Dyno load setting – time between warm up and coastdown

M. Bergmann, AUDI

WLTP-10-19-rev1

Time between warm up and coastdown - current gtr text

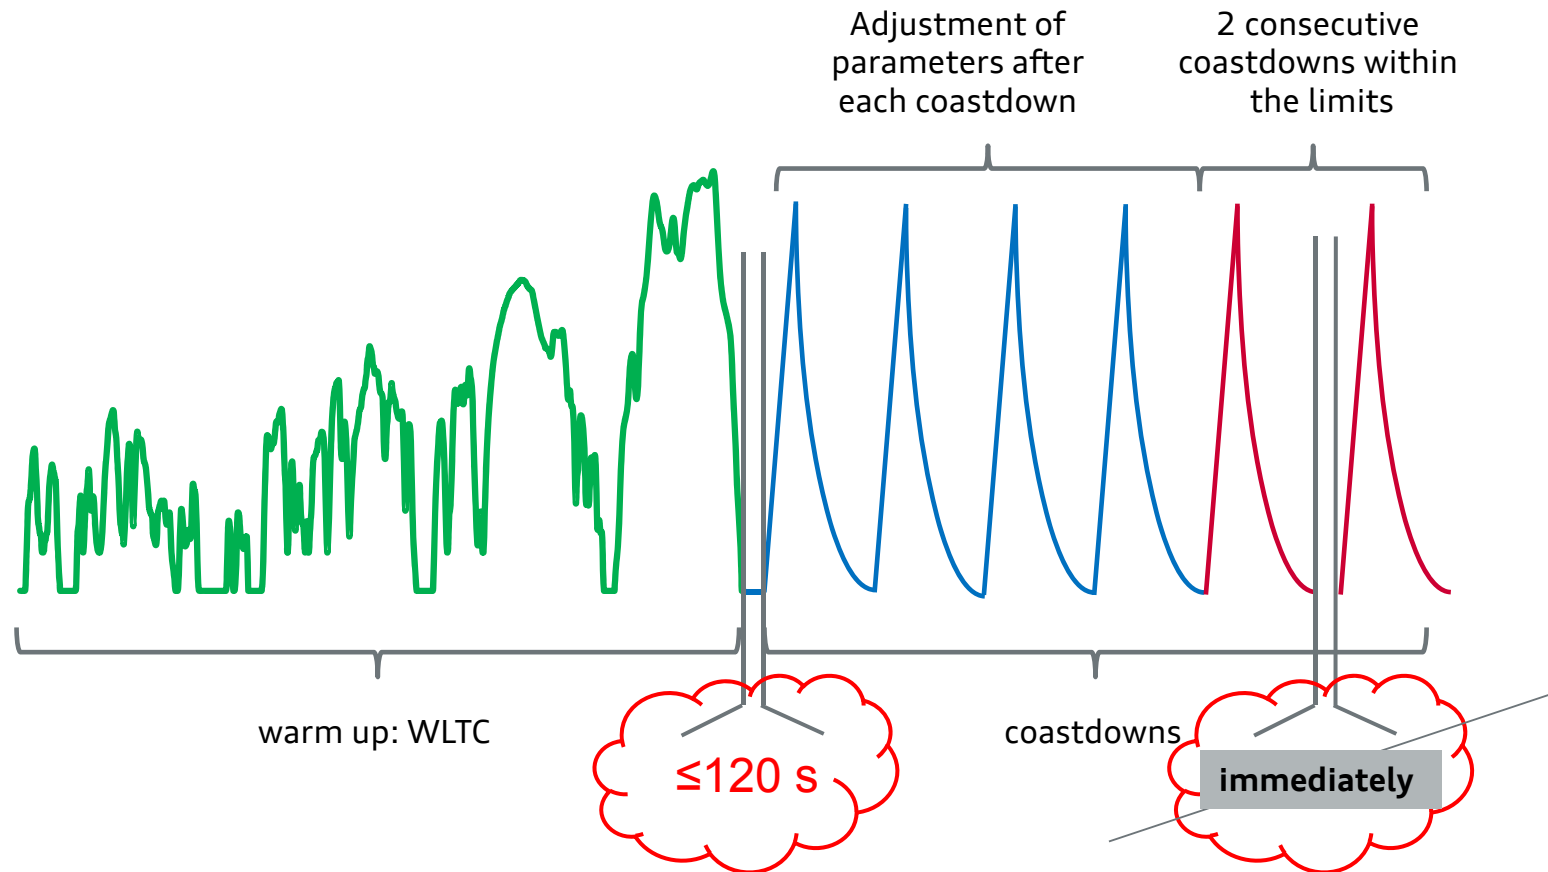
- ▶ Time between warm-up procedure and actual coastdown and inbetween individual coastdown runs is not defined

The coastdown test on the chassis dynamometer shall be performed with the procedure given in paragraphs 8.1.3.2.1. and 8.1.3.2.2. of this Annex **and shall start at latest 120 s after completion of the warm up procedure. ~~The time between consecutive coastdown runs shall not exceed 60 s.~~**

Consecutive coastdown runs shall be started immediately. At the request of the manufacturer and with approval of the responsible authorities, the time between the warm up procedure and coastdowns **of the iterative method** can be extended to ensure a proper vehicle setting for the coastdown. The manufacturer has to give evidence to the responsible authorities, that ~~the~~ additional time **is needed and** does not affect the parameters for the chassis dynamometer load setting (e.g. **coolant/oil temperature, force on a dynamometer**).
